UNC Charlotte Phase 16

Addendum #4

Revision Narrative

2021-09-08

E-008

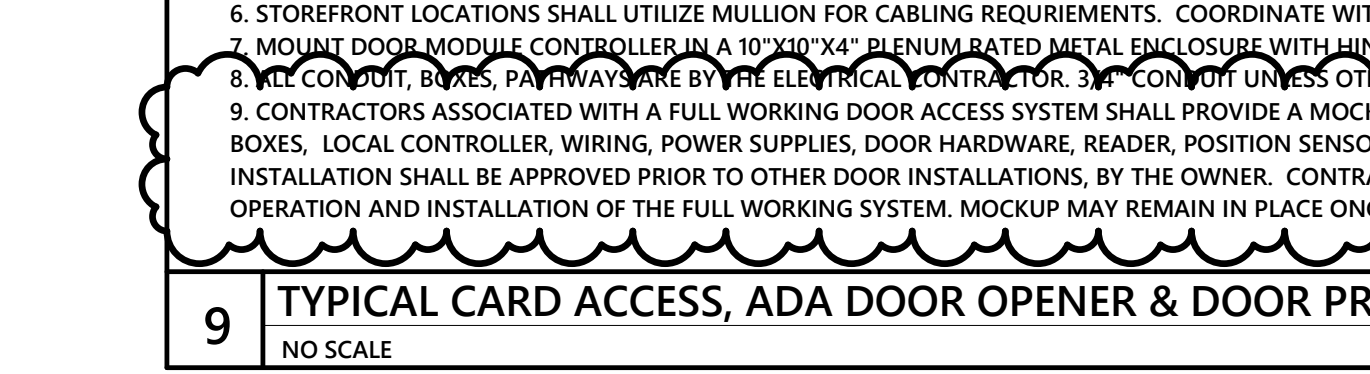
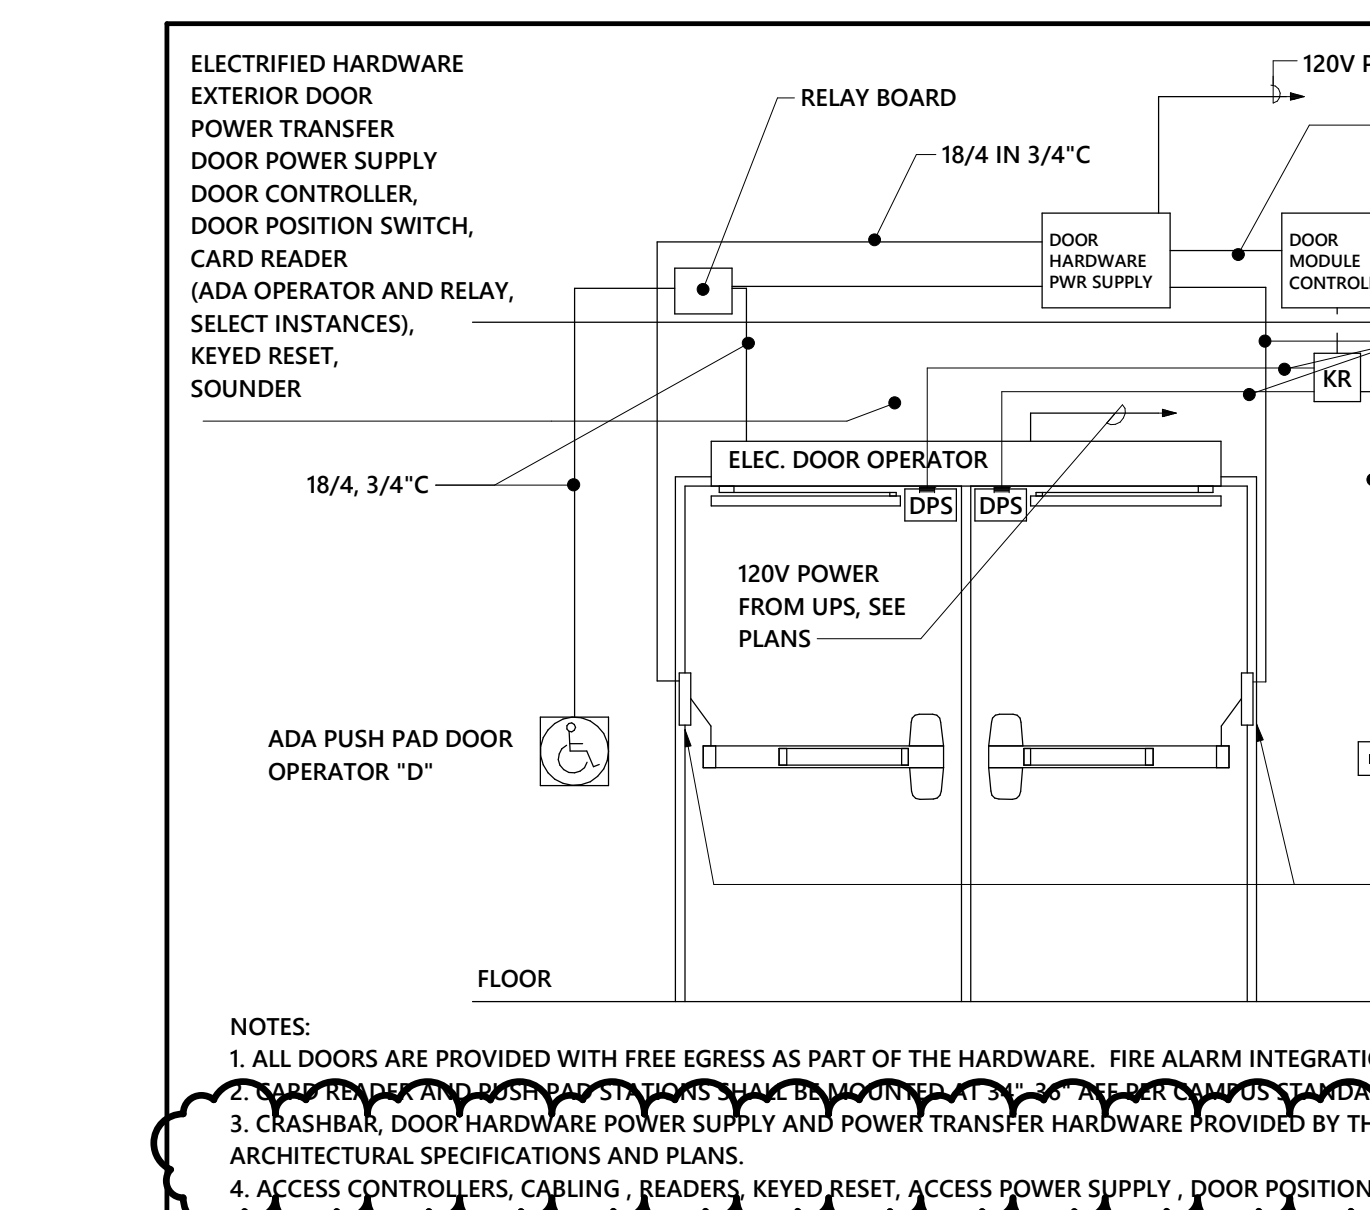
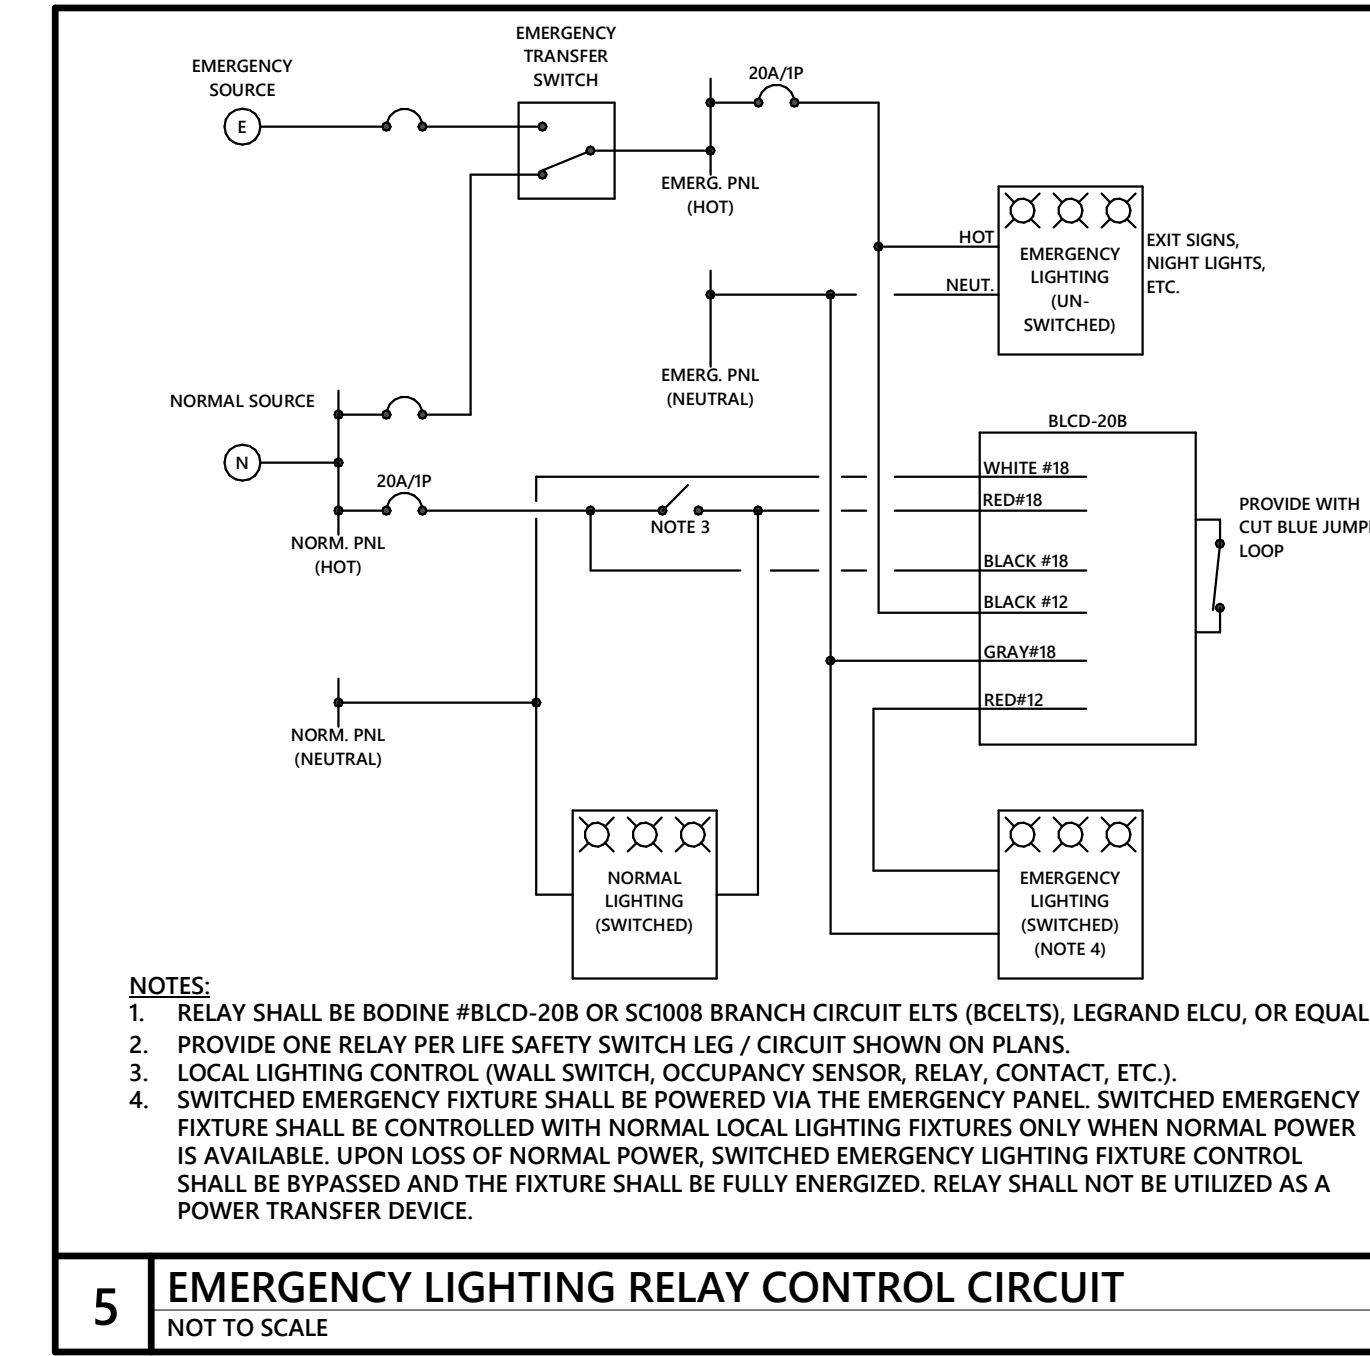
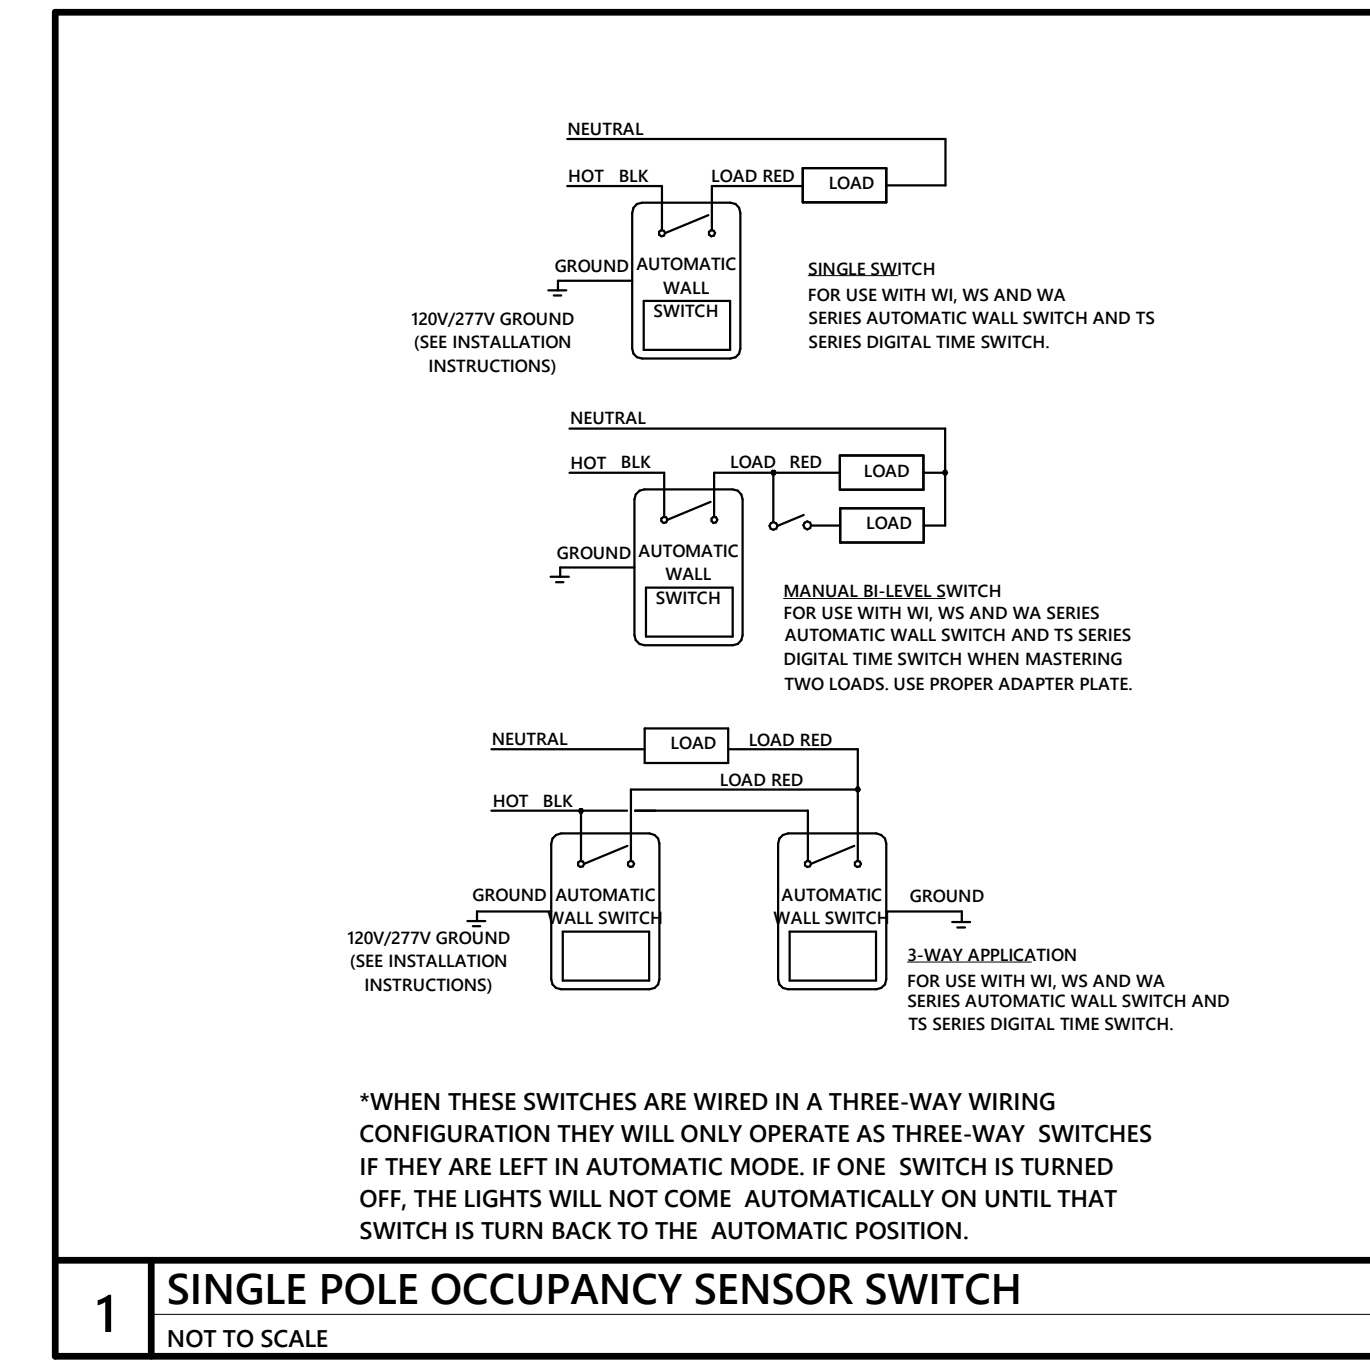
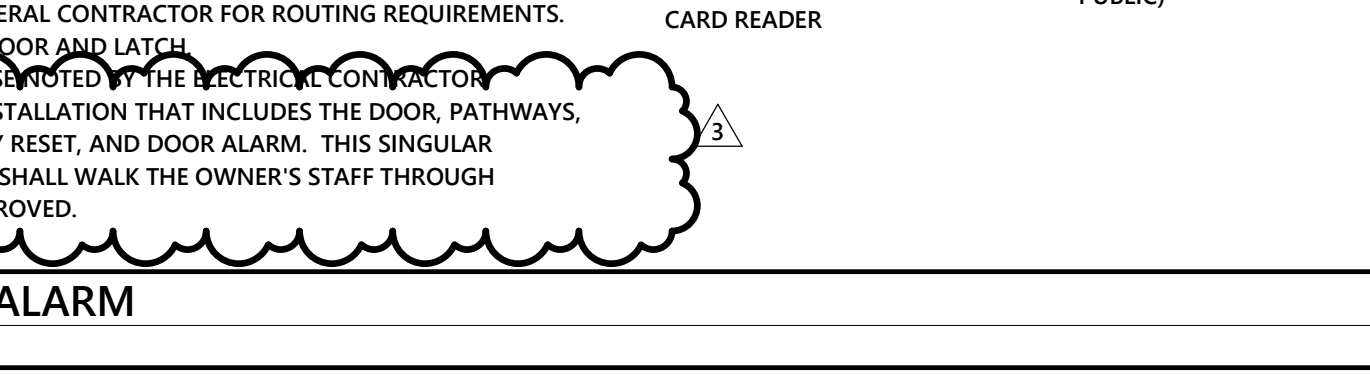
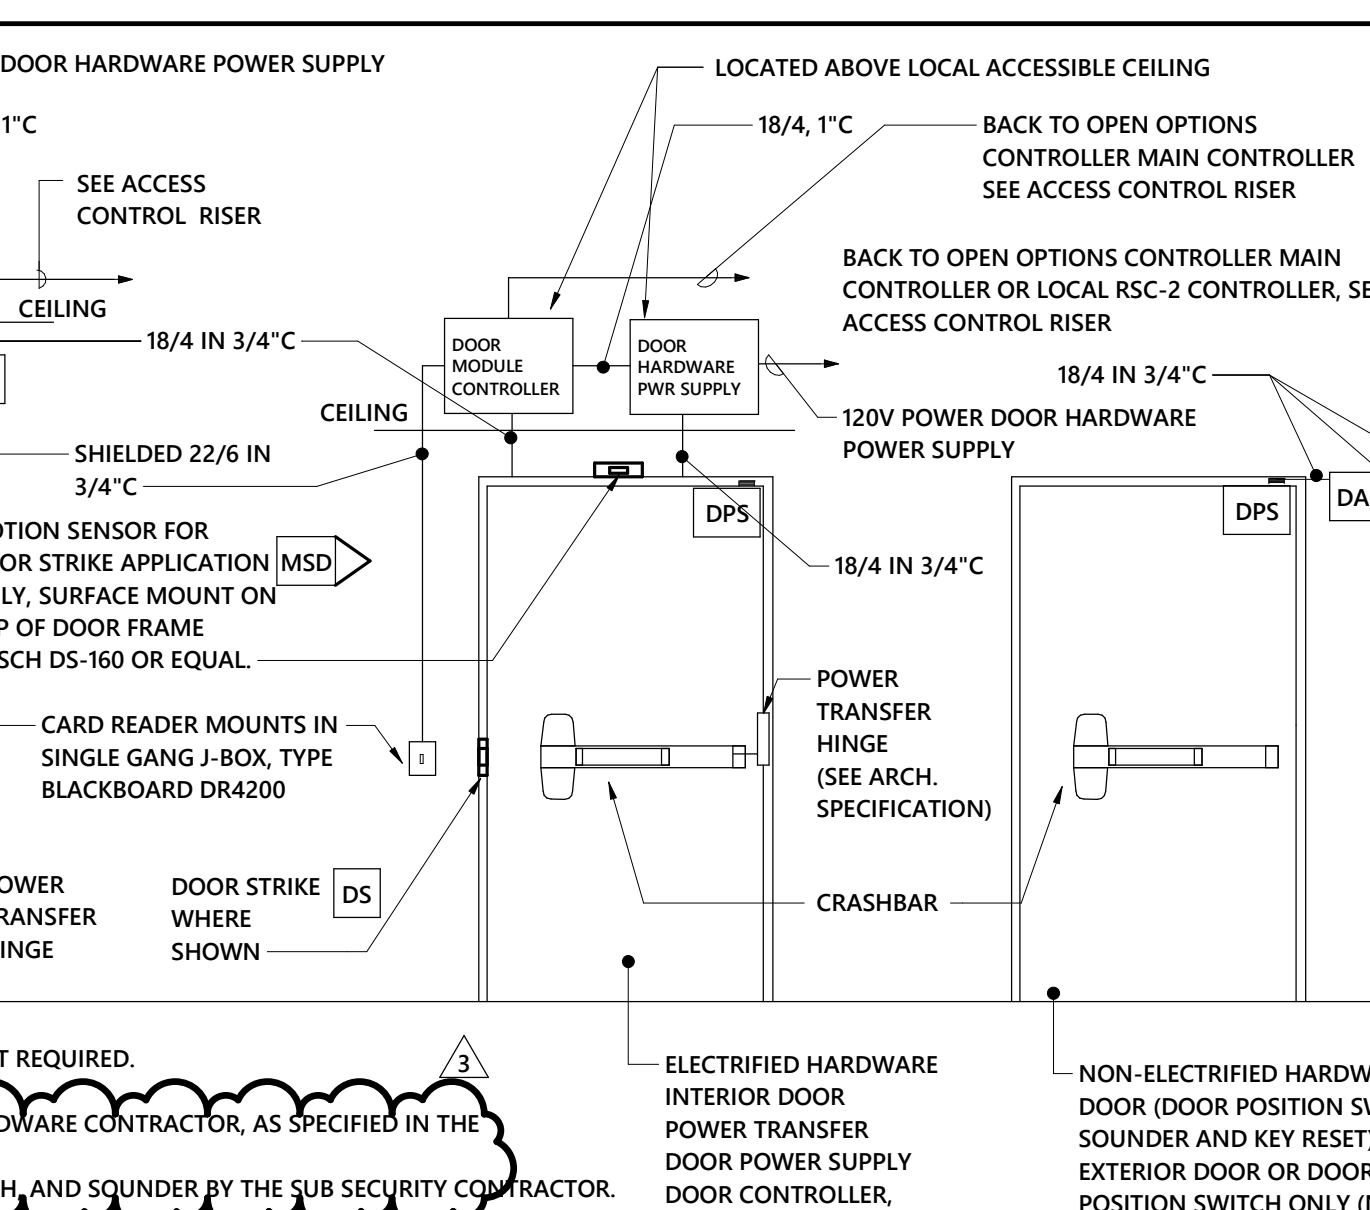
E-008 – Revisions for clarifications on access control details.
